UNITED STATES PATENT AND TRADEMARK OFFICE

10/517,845

Office Action Summary

DETAILED ACTION

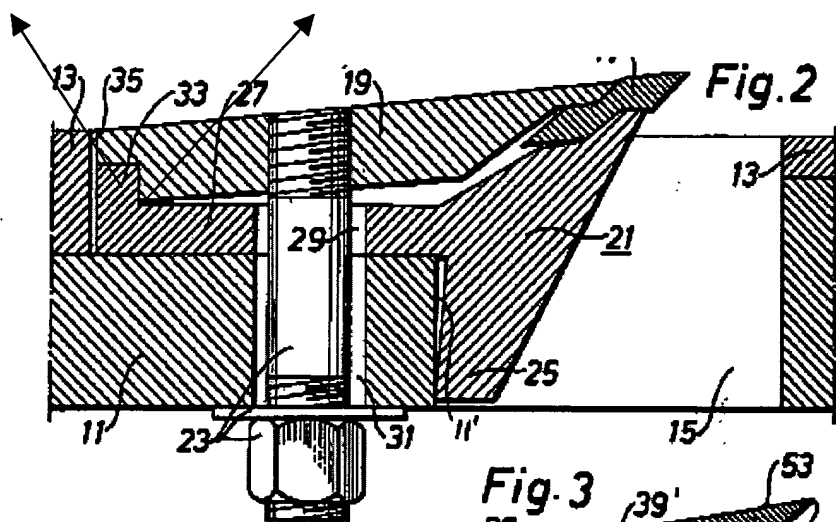
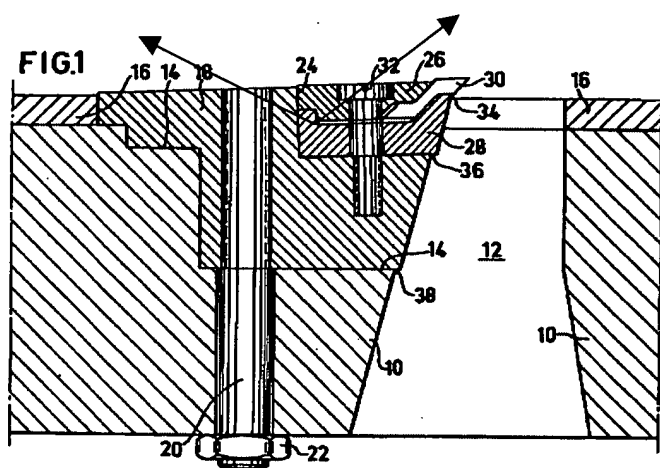
The device of either Holmberg or Svensson reads on the elements of the claimed invention including a method for clamping a knife on a chipper disk by forcing the knife in an inclined projecting position out from the disc against a wear plate fastened on the knife side of the disk, with a force substantially parallel to the axis of the disc, wherein said force parallel to the axis of the disc is exerted to the knife through a clamp having a contact to the wear plate, said contact being barred in the projecting direction to the knife wherein the force parallel to the axis of the disc is exerted to the clamp at a point towards the knife tip from said barred contact point in order to bring a turning moment to the clamp as seen in figure 1 of Holmberg or figure 2 of Svensson.

The device of either Holmberg or Svensson reads on the elements of the claimed invention including a knife disc (10 or 11), a wear plate (28 or 21), a knife (30 or 17), a clamp (26 or 19), a compressing means (20 or 23), a bracket (see marked copy of fig 1 of Holmberg or fig. 2 of Svensson), a matching groove, a cam and a projection. The clamp of Holmberg or Svensson is supported against a perpendicular direction, parallel with a compressive motion, by the bracket abutting the matching groove.
